CITY OF ALBUQUERQUE

August 11, 2023

**RE: 1756 Cliffside Dr. NW
Grading & Drainage Plan
Engineer's Stamp Date: 07/13/23
Hydrology File: H11D015C**

LOTS A-26-A & A-26-B BLOCK, 4
GRADING PLAN

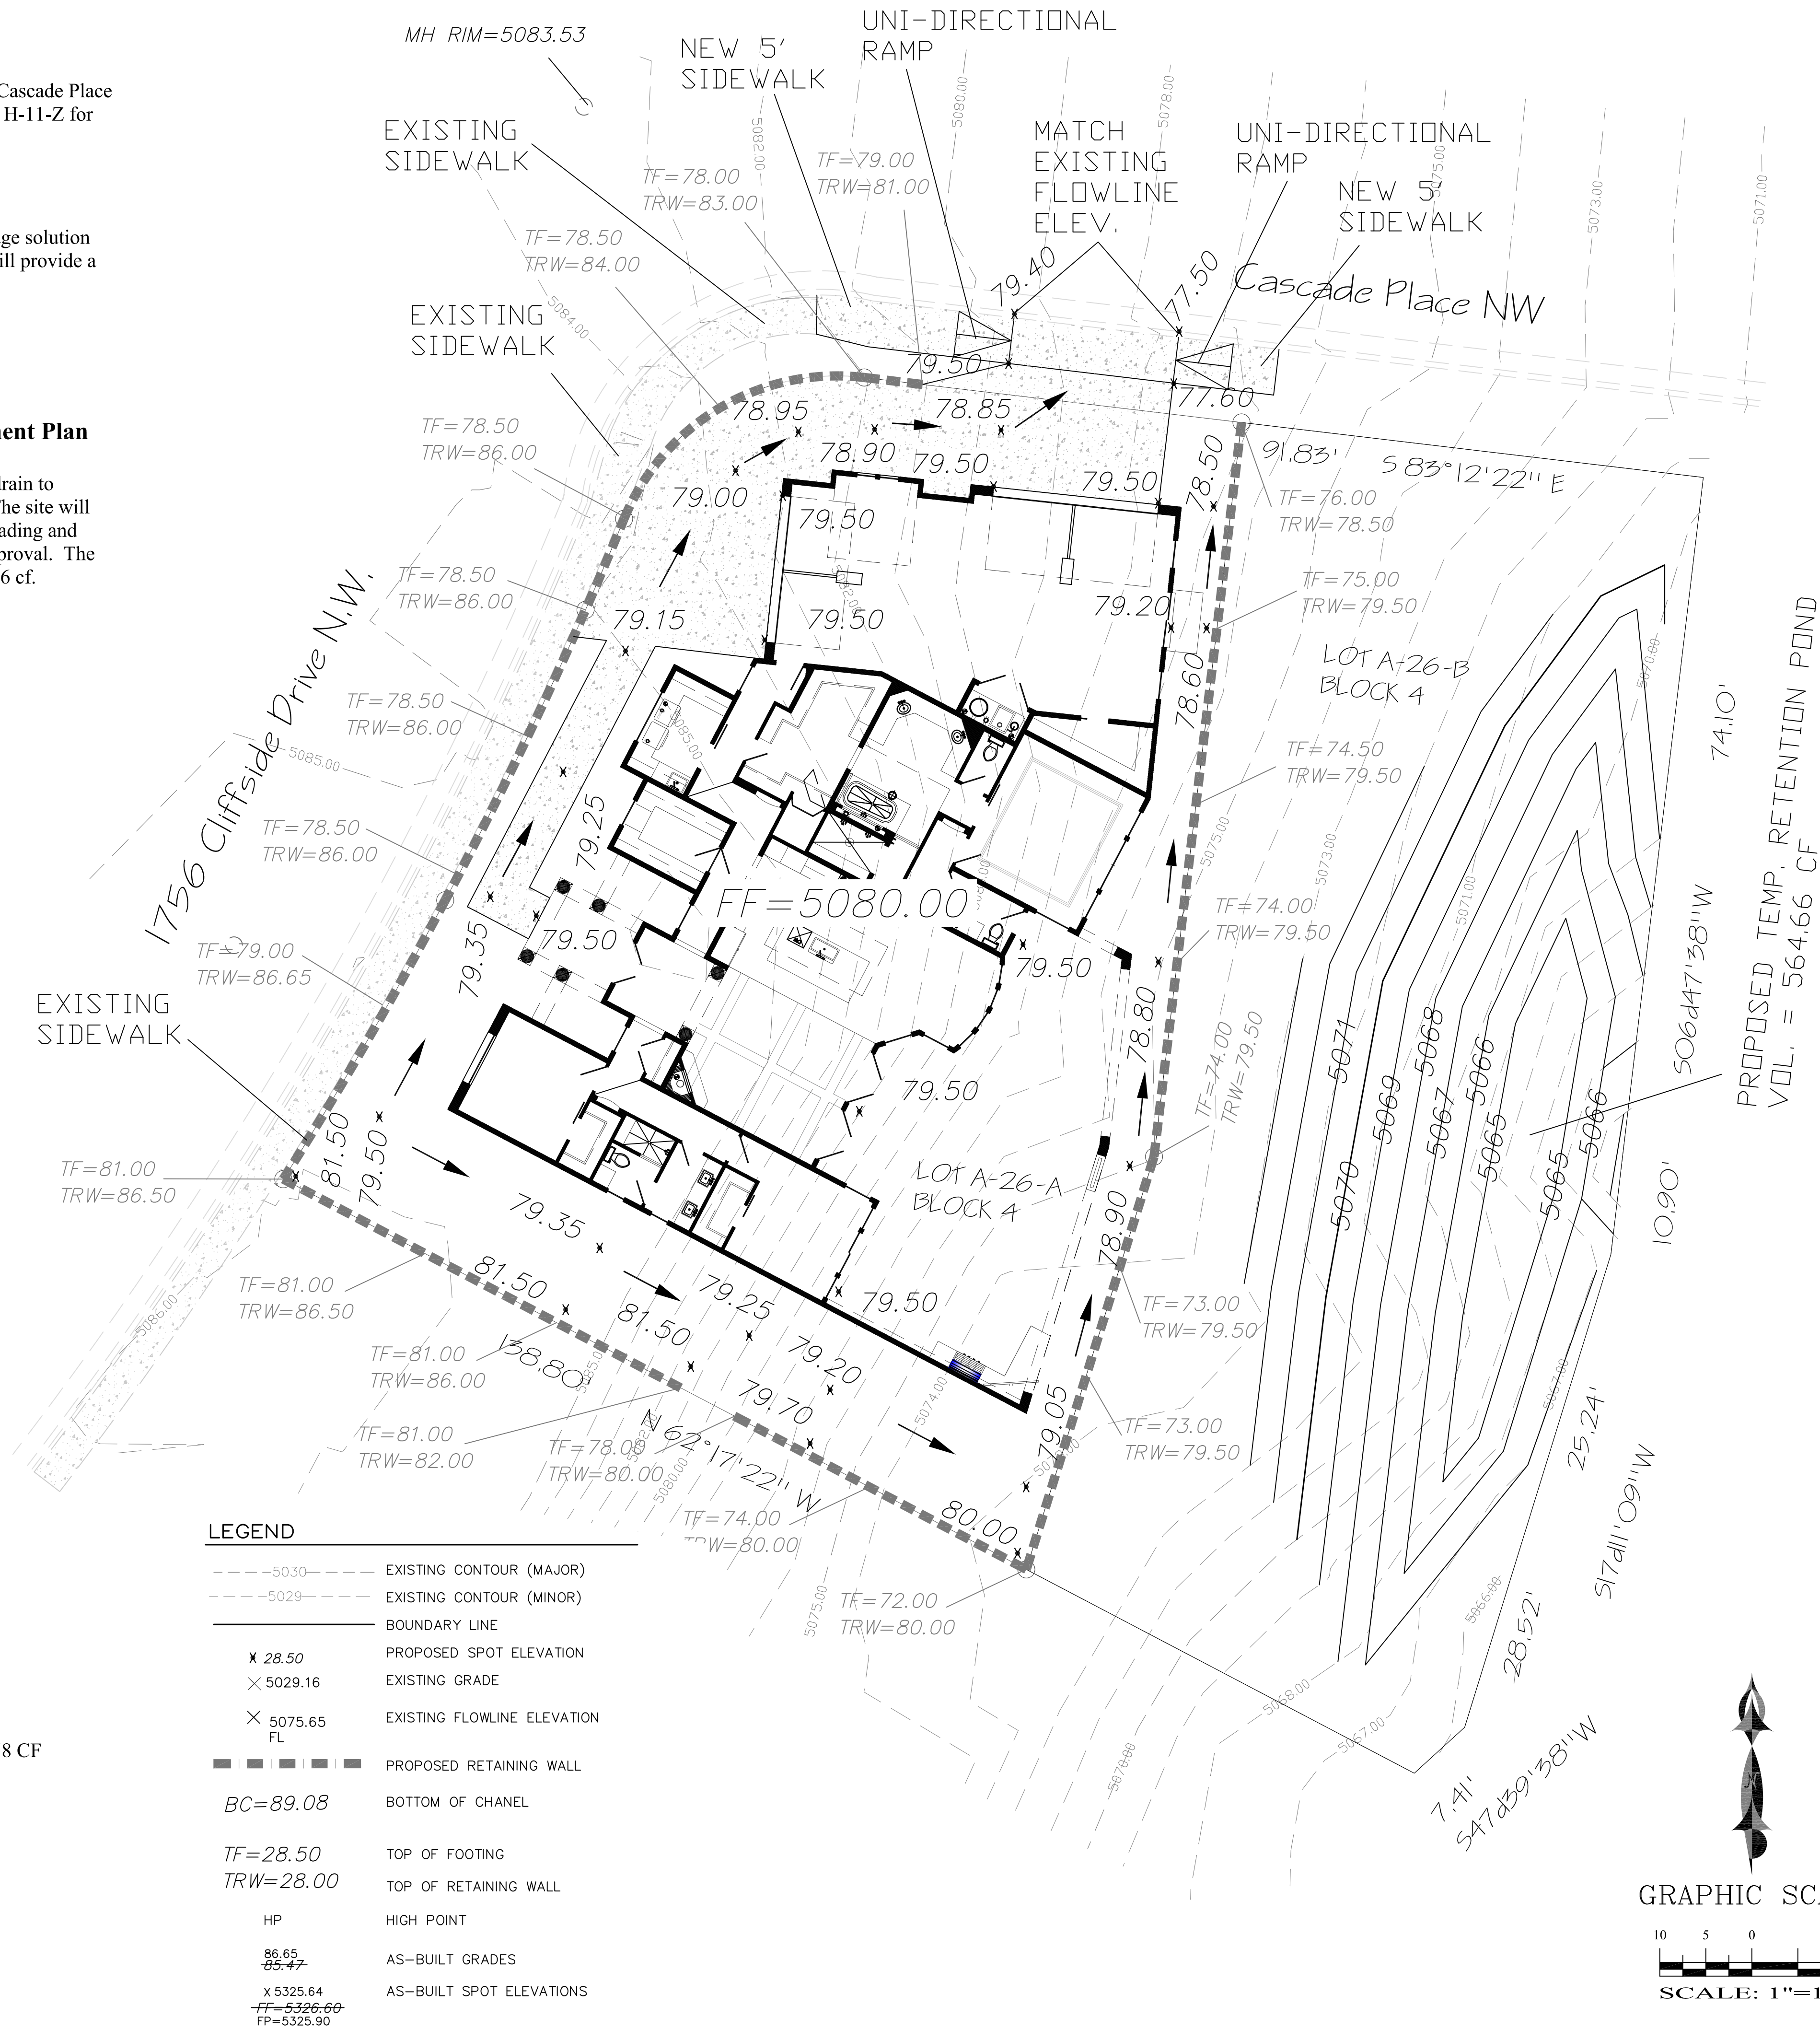
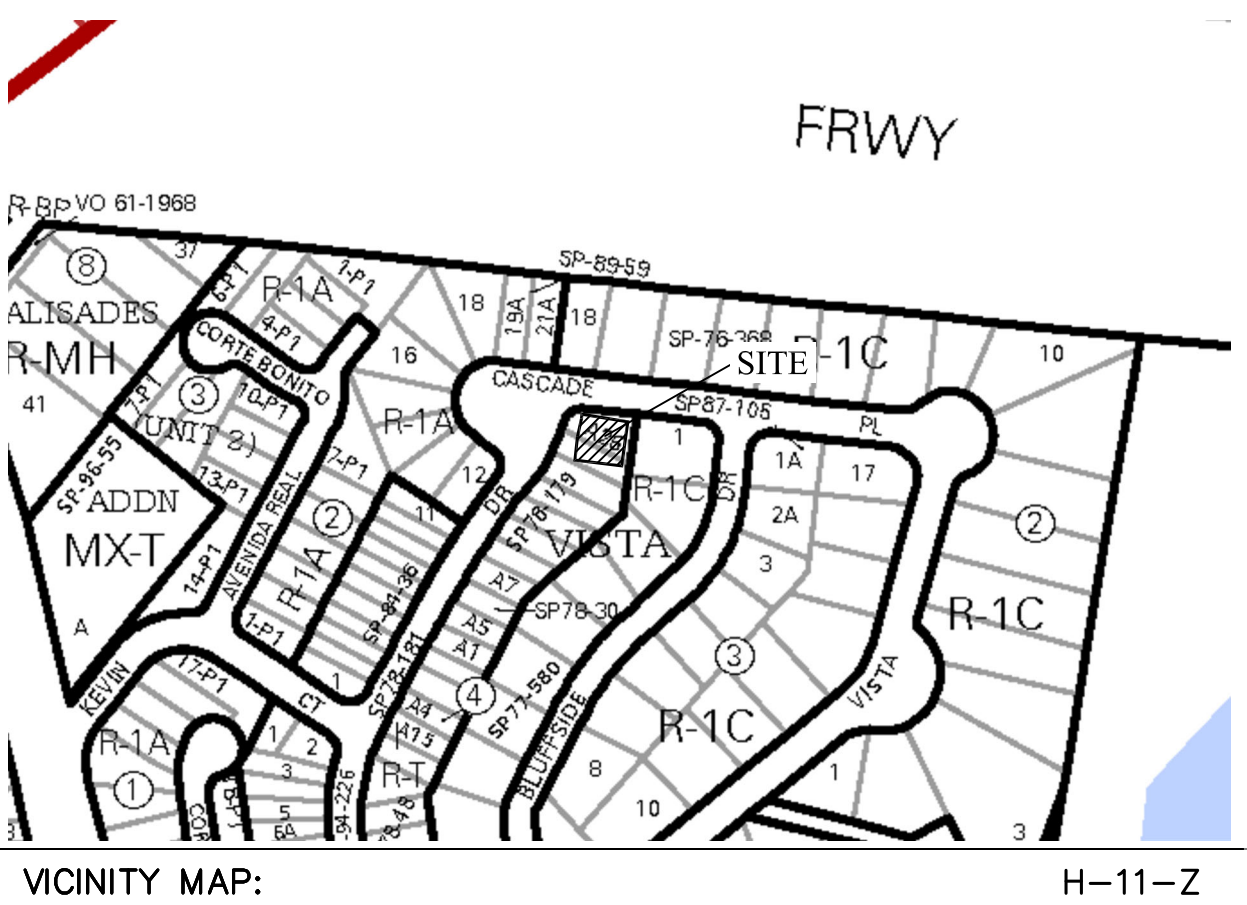
Based upon the information provided in your submittal received 08/03/2023, the Grading & Drainage Plan is approved for Grading Permit (earthwork can get started for the earth pad on the house) and for action by the Development Hearing Officer (DHO) on Preliminary/Final Plat.

1. Once the grading is complete, a pad certification (meaning that the earthwork and retaining walls are complete) will be required. Please include a site photo with the submittal. Also, at the time of pad certification approval, Hydrology will concurrently approve the Grading & Drainage Plan for Building Permit.
